Bicycle Advisory Committee
CORRESPONDENCE

2015 DTX draft SEIR

SFCTA March 14 Board meeting Item #12 update on the Railyard Alternatives

1) Train Box Extension

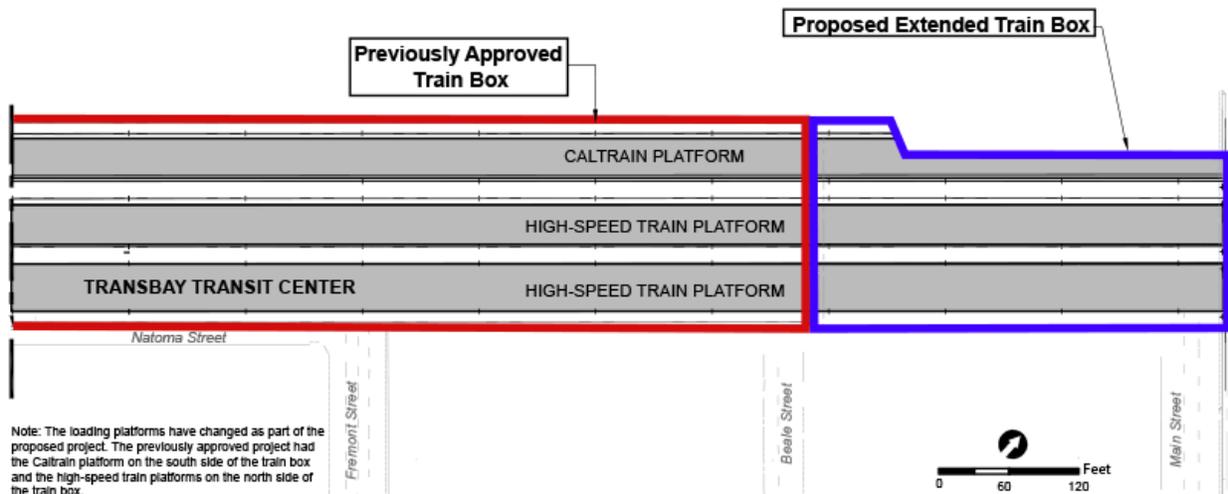
- The train box extension design violates SB916 (2003) codified in Streets & Highways Codes section 30914(22) (<http://law.justia.com/codes/california/2011/shc/division-17/30910-30922/30914>) by failing to provide any kind of engineering solution for a future East Bay extension

- The proposed Caltrain storage is insufficient to enable Caltrain to vacate the 4th & King railyard until after relocation to Oakland.

Recommendation #1

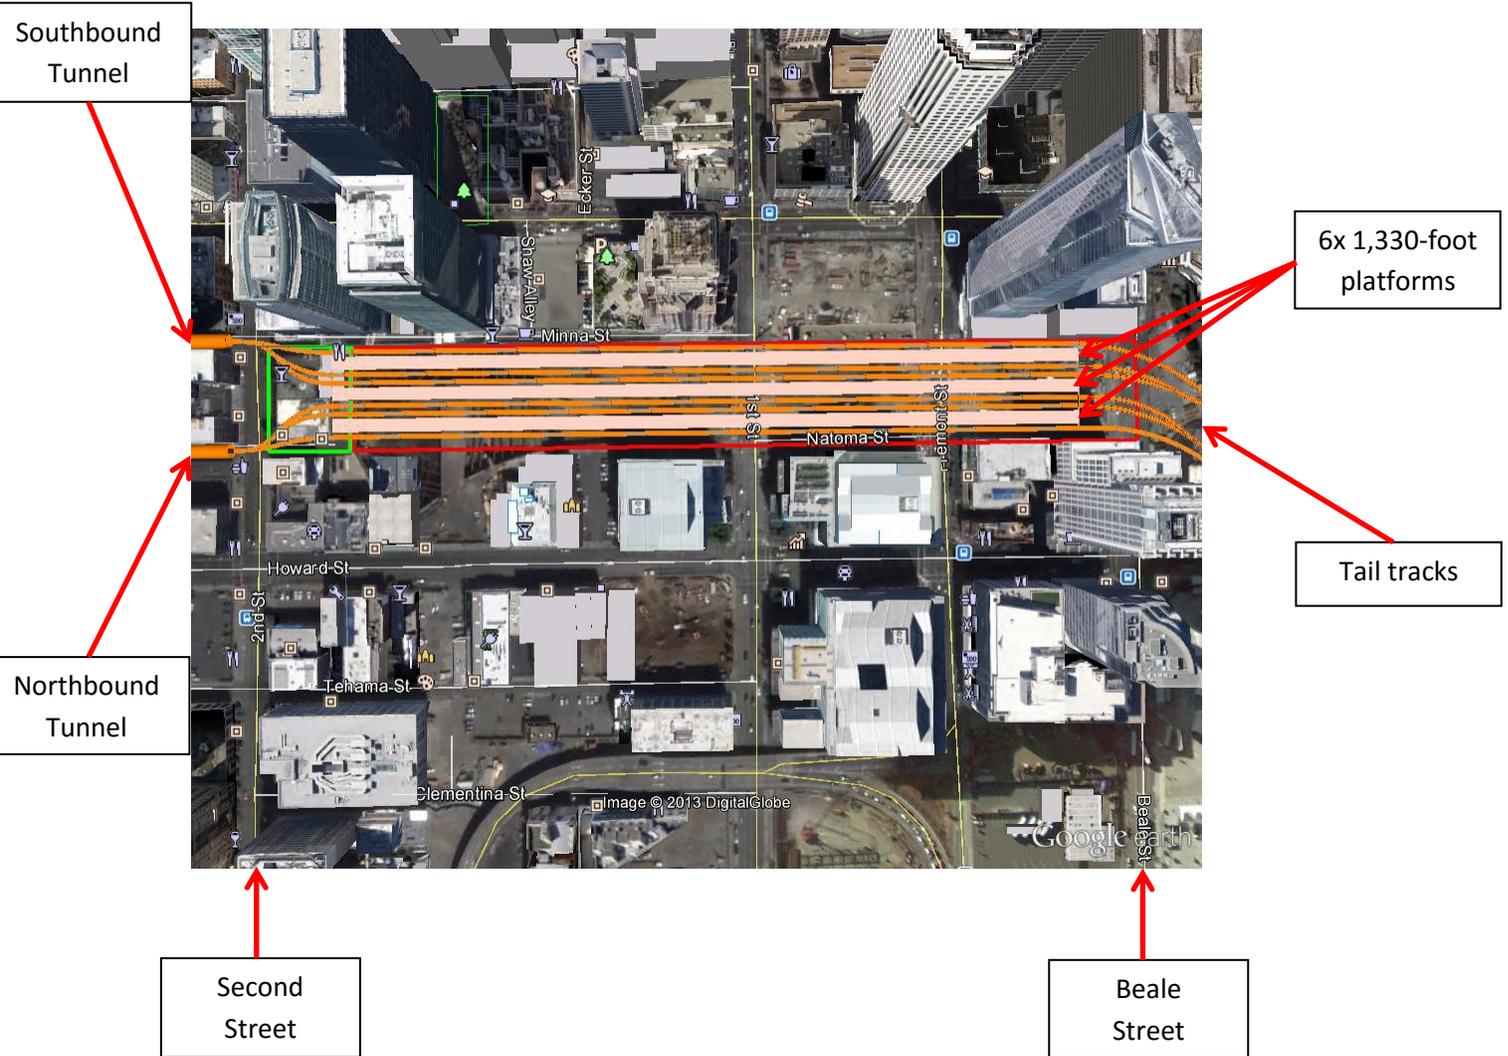
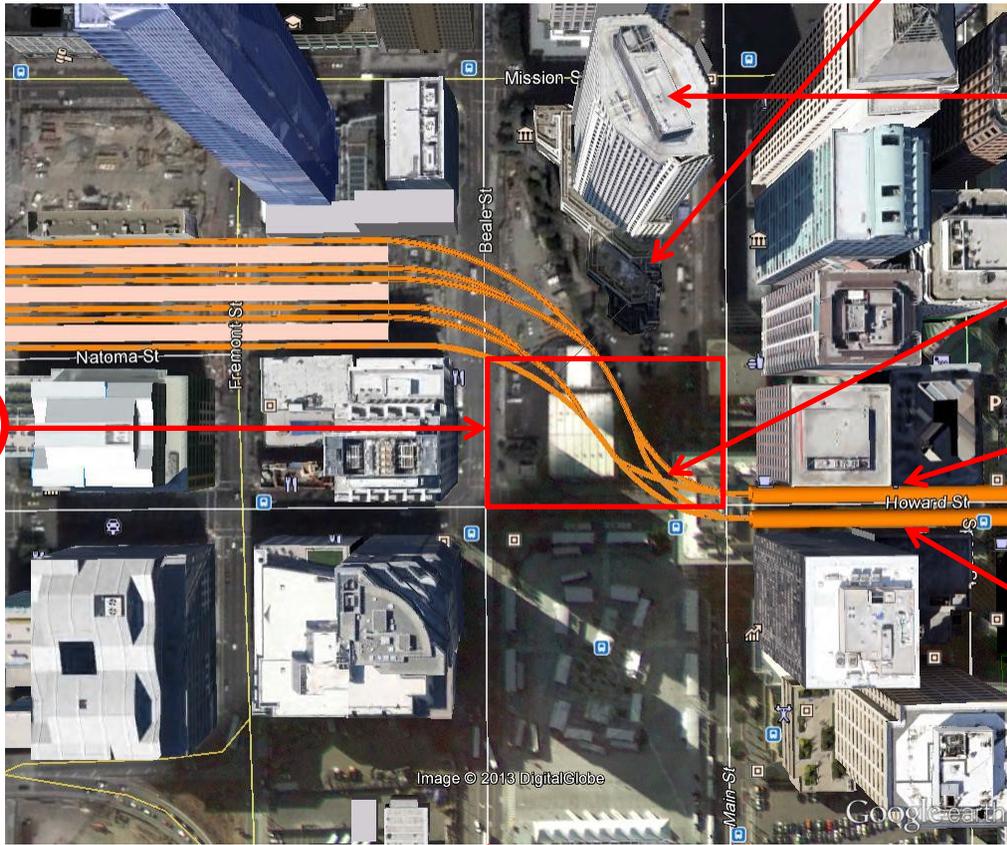
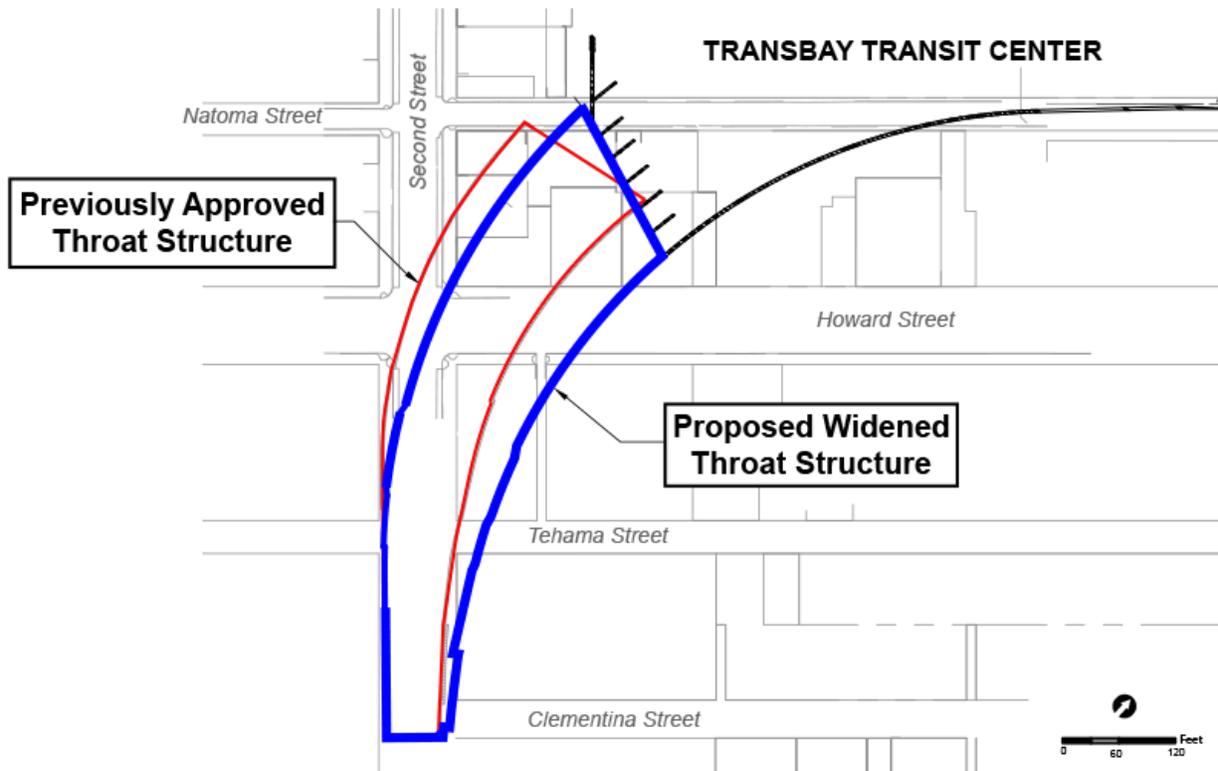
The SEIR should consider an alternate DTX alignment which would enable platform lengthening by extending the train box one block west (towards 2nd Street) while simultaneously providing a viable connection to a Transbay tunnel. This alignment would also eliminate conflicts with the 201 Mission building and enable a 6th full-length through platform (total 3 eastbound and 3 westbound platforms).

This alignment would eliminate the need to demolish the 201 Mission podium structure.

Recommendation #2

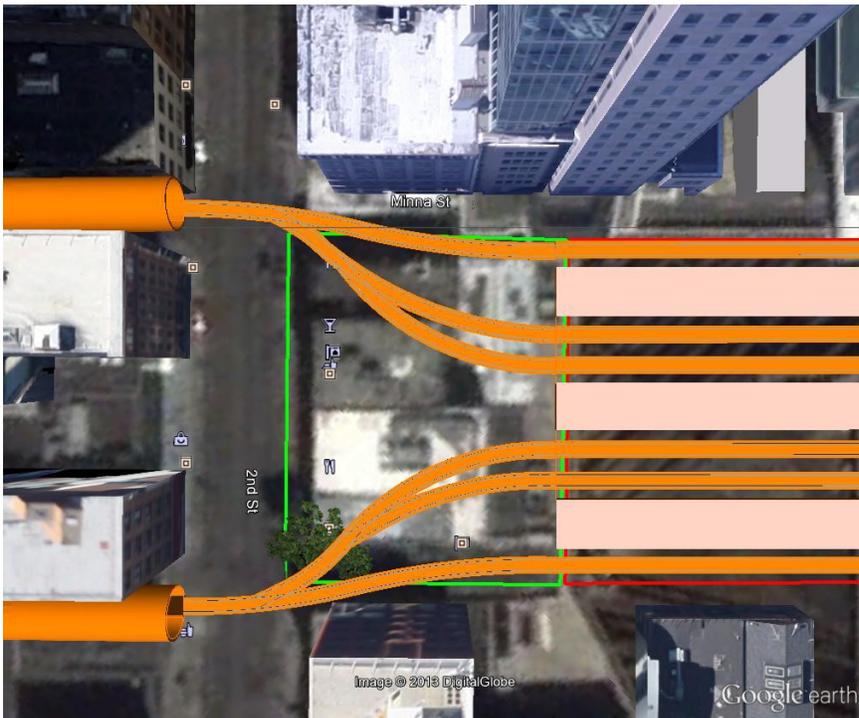
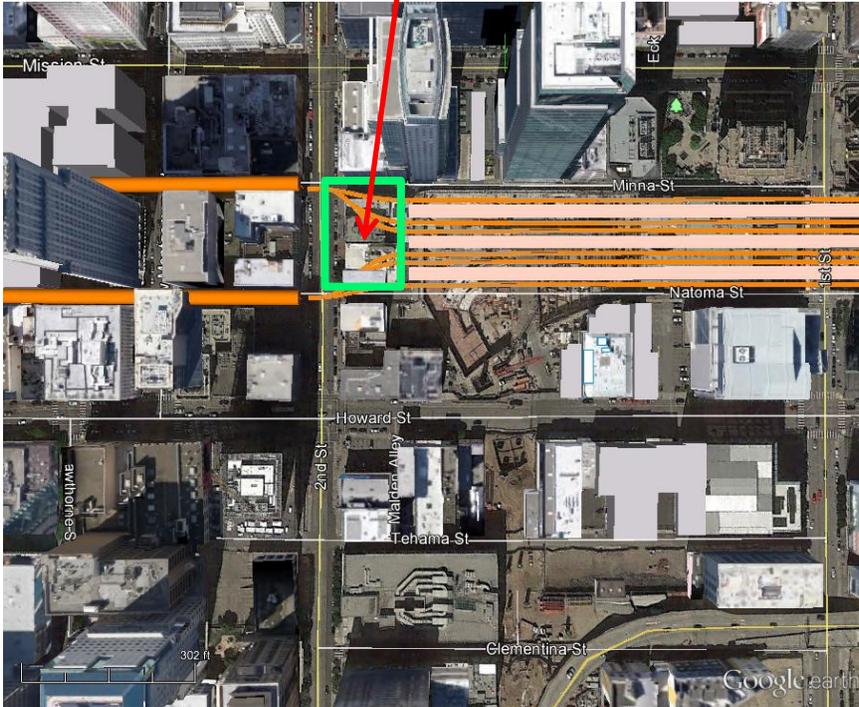
The SEIR proposes a widened approach to the Transbay Center train box via a massive cut & cover structure that will impact numerous properties as far south as Clementina Street. Construction costs are expected to run into the hundreds of millions and will result in massive circulation and noise impacts on the adjacent neighborhoods for many years.

The SEIR should consider an alternate DTX alignment and construction technique that would limit impacts to a small number of buildings on 2nd Street between Minna and Natoma. There would be no additional surface impacts in SOMA north of Townsend.

3) Tunnel design

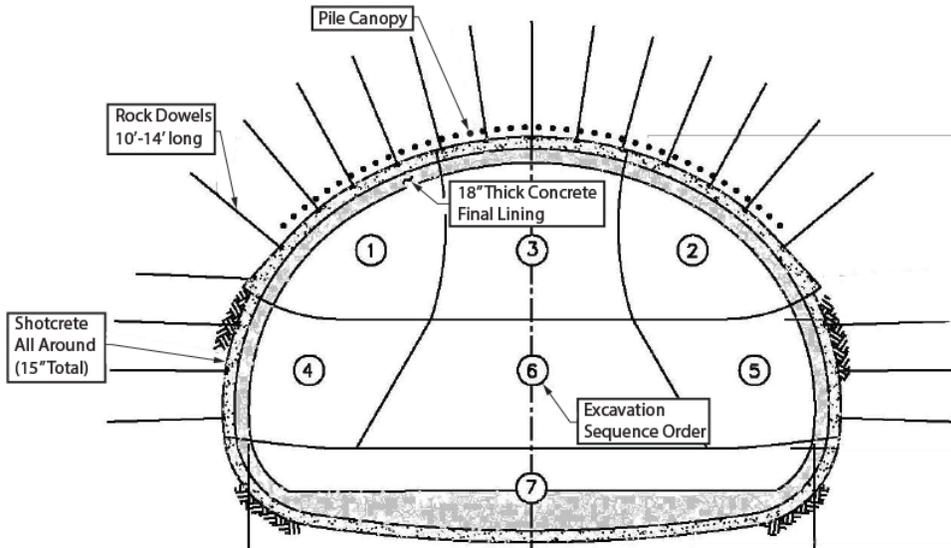
The current DTX design contemplates the construction of a 3-track sequentially excavated tunnel without any apparent plans for the evacuation of a train travelling on the middle track. This is of particular concern with High Speed trains which have a single door per carriage.

The SEIR should consider a twin-bore tunnel design with cross-passages for emergency evacuation (similar to the Central Subway) and a ventilation system designed to eliminate any requirement for vent/evacuation structures north of Townsend.

5) 7th Street Tunnel Stub Box

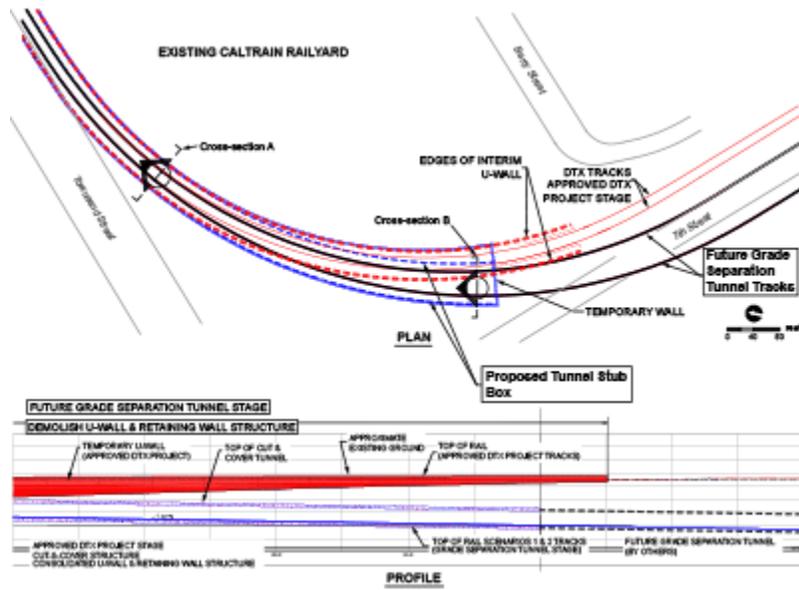
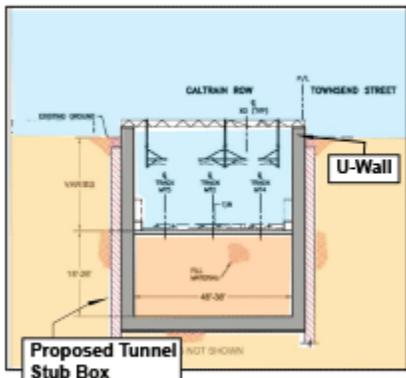
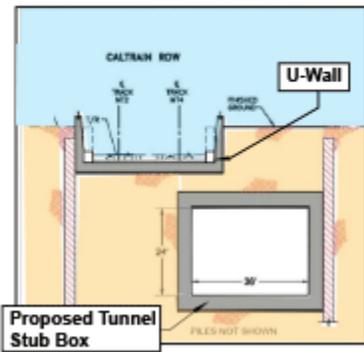
The SEIR proposes to terminate the DTX on 7th Street with a “tunnel stub box” designed to accommodate a future 16th Street grade separation.

Recommendation #5

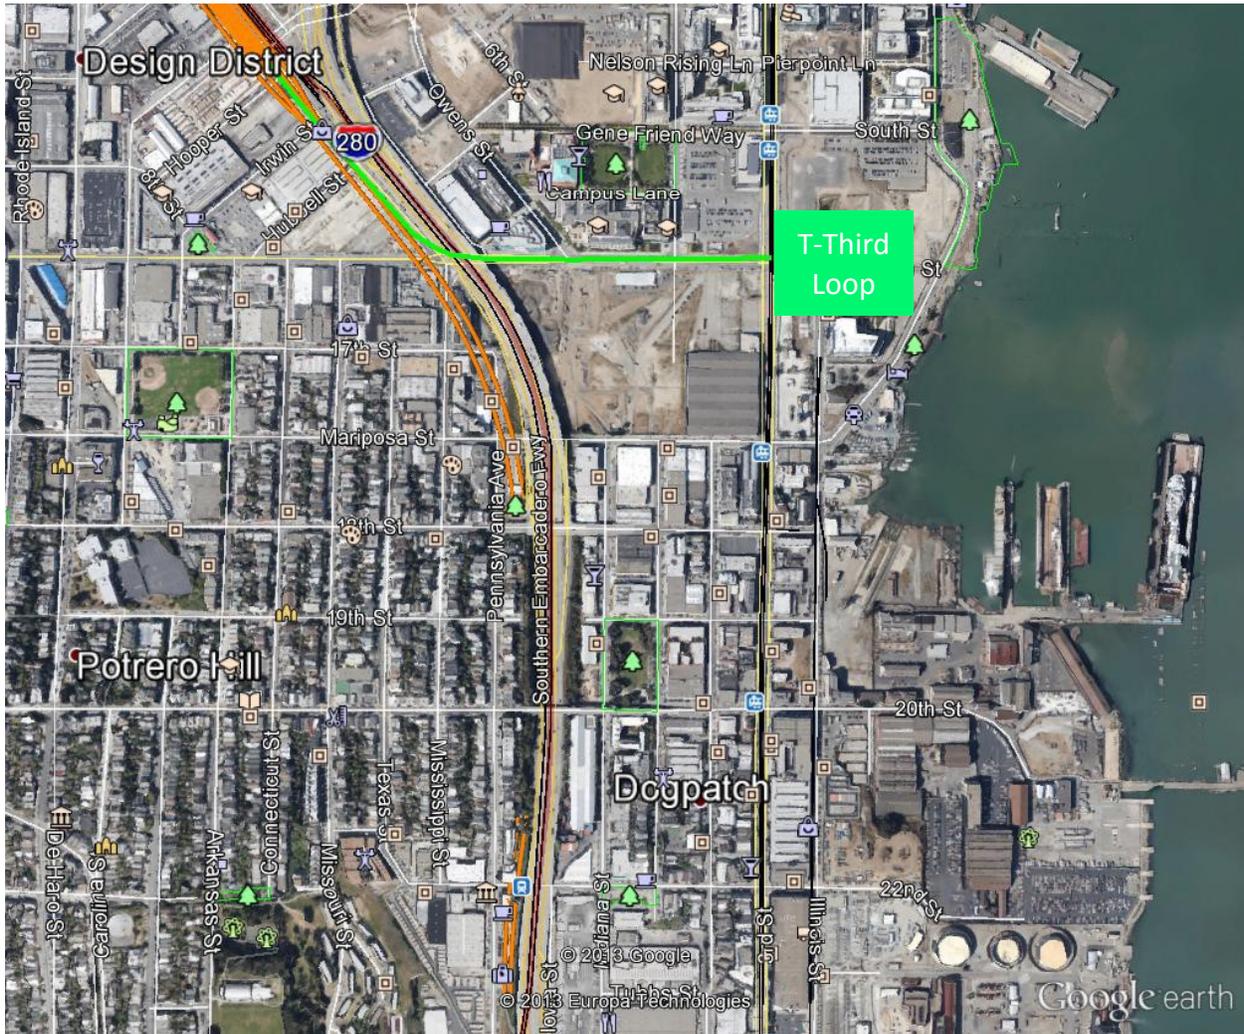
The SEIR should consider a direct connection to the Planning Department's Pennsylvania Avenue RAB study alternative. This would achieve 16th Street Grade separation as soon as Caltrain operations are relocated to the Transbay terminal and would save hundreds of millions by eliminating cut & cover structures @ 7th & Townsend

6) Turnback Track impacts on 16th Street grade crossing

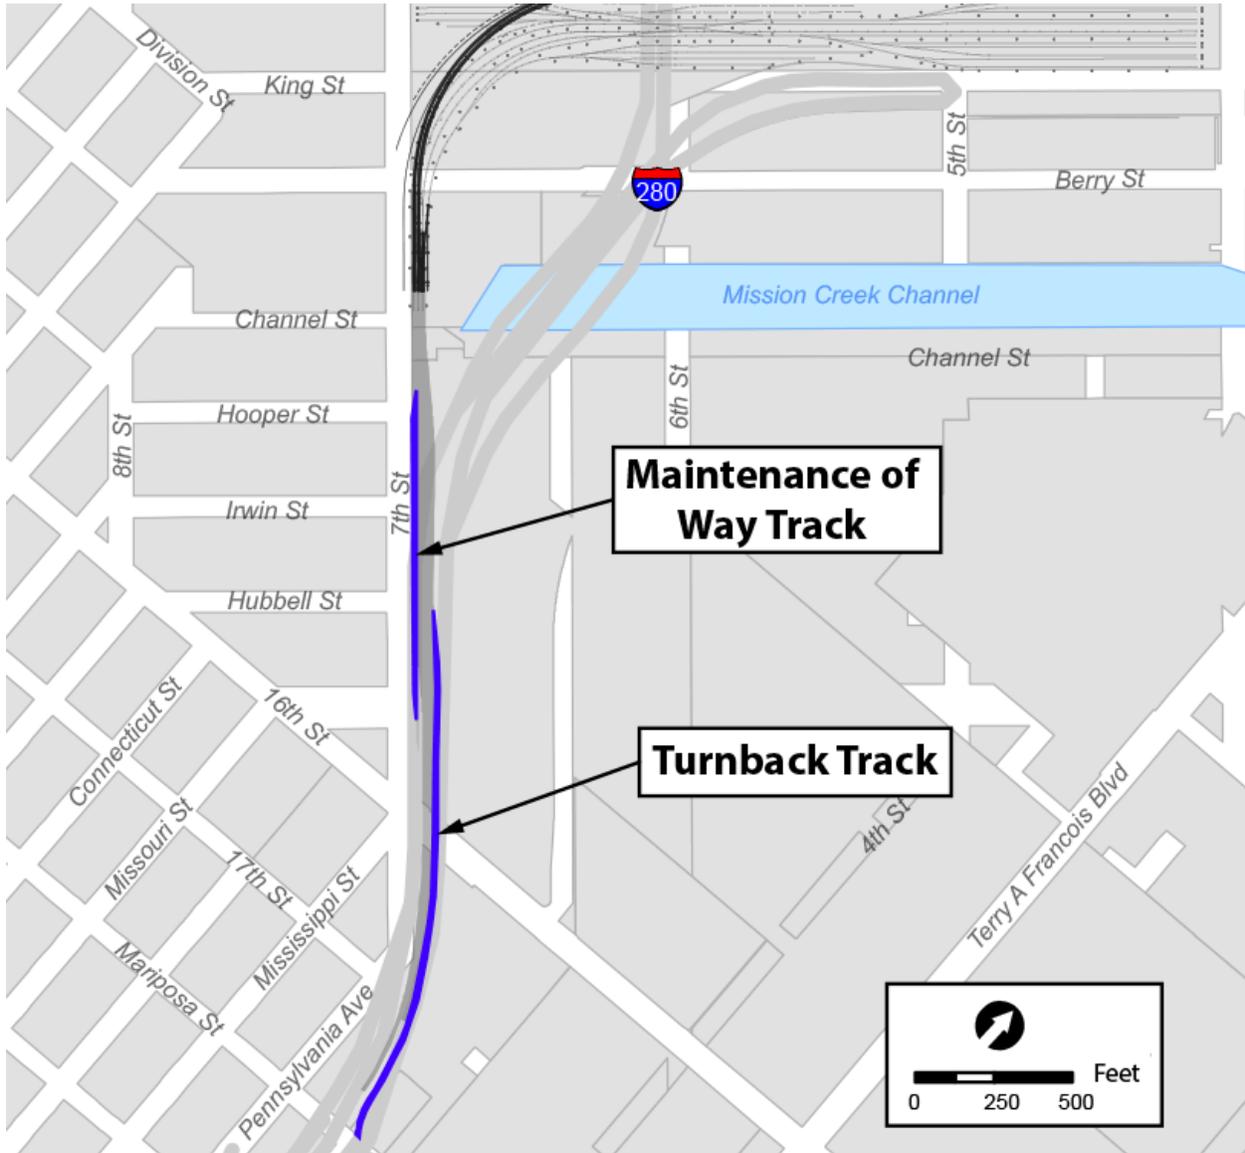
The SEIR proposes the addition of two additional tracks on 7th Street, including a turnback track across 16th Street, thereby increasing gate downtime for each train crossing by an additional 10 seconds (10 minutes per day).

The SEIR should consider a direct connection to the planning department's Pennsylvania Avenue alternative (see recommendation #5 above) and turn trains around further south. The SEIR should also consider the abandoned tunnel #1 for storage.

Recommendation #7

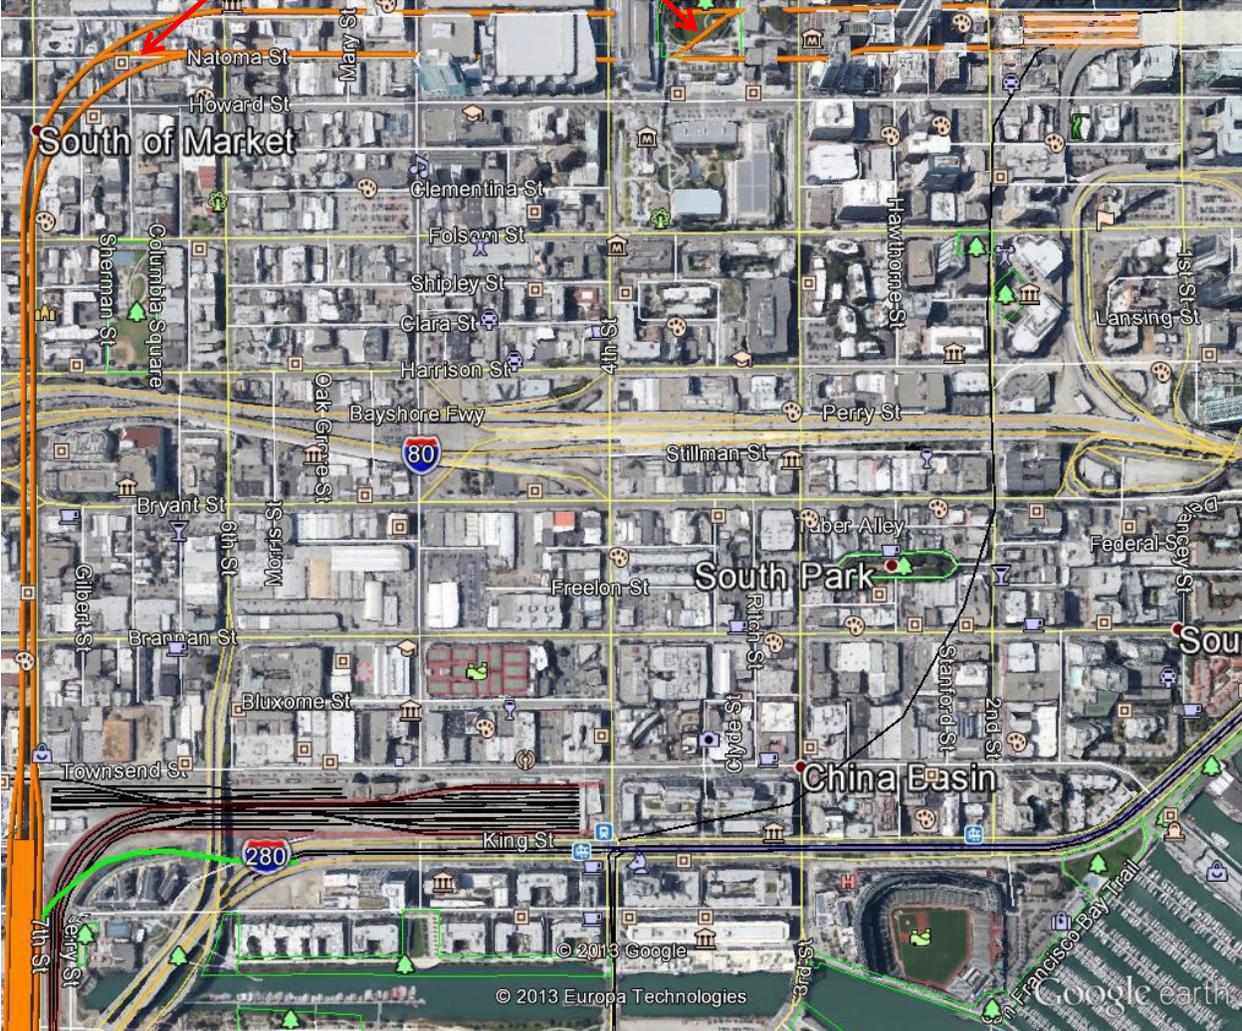
The current DTX alignment consists of 3 sharp curves each with a maximum speed of 25 MPH which extend the travel time between 7th Street and the Transbay Terminal by an additional 3 minutes.

The SEIR should consider an alternate alignment designed to enable an 80 MPH approach to the Transbay Transit Center.
